Application to Amend Certificate of Compliance

Applicants: Montana Alberta Tie Ltd. and MATL LLP, Co-Permittees
Project: Montana Alberta Tie 230 kV International Transmission Line
Certificate: October 22, 2008, Certificate of Compliance; Montana Alberta Tie Ltd.
Date: April 2, 2012
Notice Dates: March 24, 2012 (Great Falls Tribune); March 28, 2012 (Choteau Acantha); March 29, 2012 (Conrad Independent Observer).

Figure A:

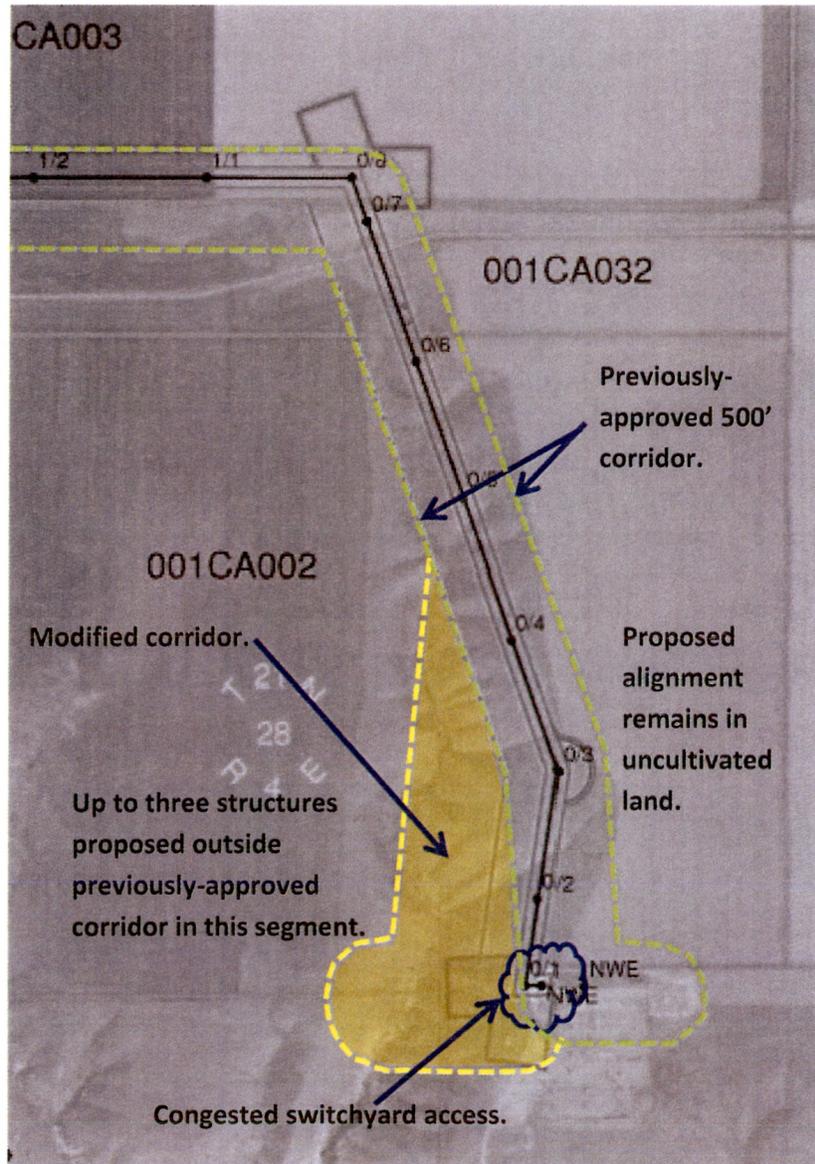
A. Alternative 4 – Great Falls Switchyard Modification:

Based on landowner coordination and the identification of design constraints at the NorthWestern Energy switchyard at the MATL project terminus at Great Falls, the transmission line corridor would be modified from approximately milepost 0/1 to 0/4 as depicted in Figure A. This proposed alignment modification shifts the north/south tangent run of the MATL transmission line west of and away from a number of existing and planned power lines coming into the same switchyard. While modified from the original design, the alignment would still fall within the approved 500-foot corridor from approximately milepost 0/4 to 0/8. It is anticipated that only two to three structures would lie outside the currently-approved corridor.

Alignment Modification A shifts the alignment and structure locations further away from an increasingly congested entryway to the NorthWestern Energy switchyard at Great Falls, thus improving the design and operation of the facility overall. The modification lies mostly within the previously-approved corridor, but it is currently anticipated that two to three structures would be located outside the 500-foot corridor. This newly analyzed portion lies within an uncultivated coulee and has been surveyed for cultural and biological resources. No sensitive features have been identified. This new alignment was proposed by NorthWestern Energy and is supported by the neighboring affected landowners.

Figure B:

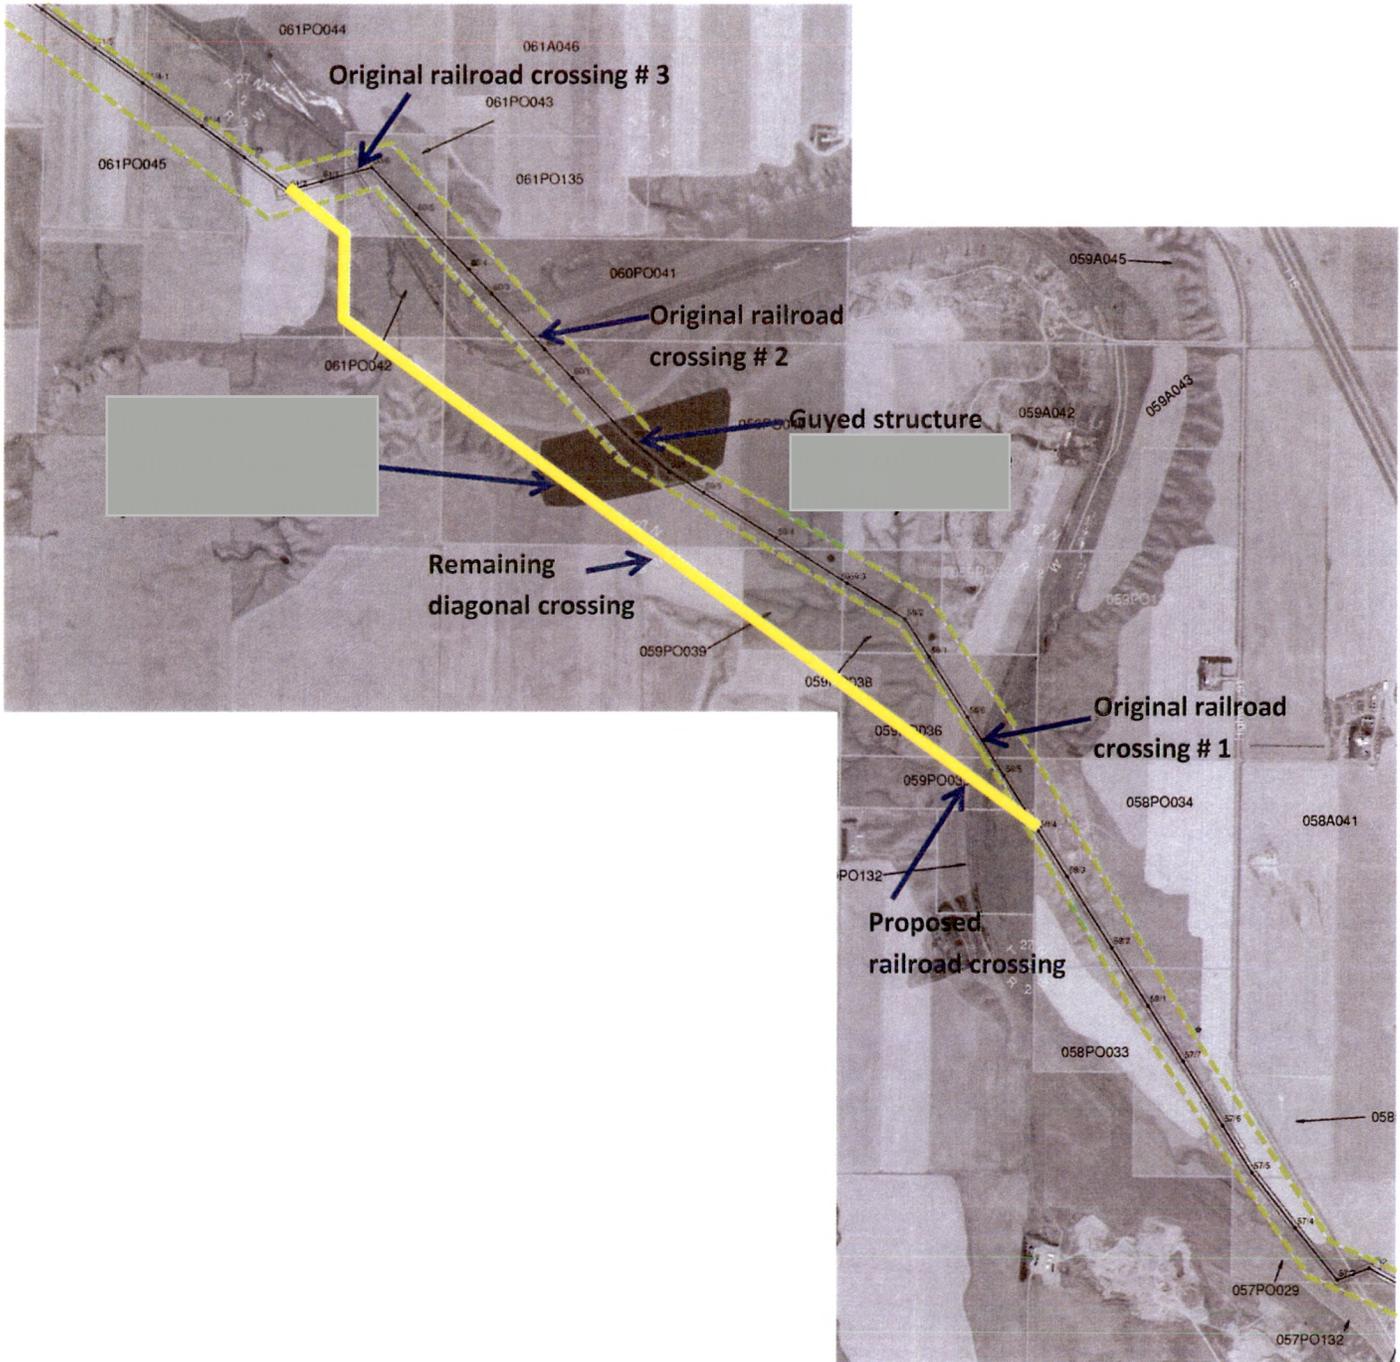
B. Southeast of Conrad – Banka Modification:

At Mr. Banka's request, the transmission line corridor would be modified from approximately milepost 58/4 to 61/2 as depicted in Figure A. This proposed alignment modification shifts the transmission line away from a number of cultural features, and provides better opportunity for structure placement outside of cultivated fields. This proposed alignment modification also reduces the number of railroad crossings required in this segment.

Alignment Modification B shifts the alignment and structure locations away from the center of a cultural resource site, thus reducing the potential for encountering cultural features during construction and maintenance of the line. The modification lies mostly within broken, uncultivated terrain, thus reducing the amount of line previously approved for location in cultivated fields. A diagonal crossing of a minimal amount of cultivated land is still required for this modified alignment. This diagonal crossing was proposed by and supported by the affected landowner.
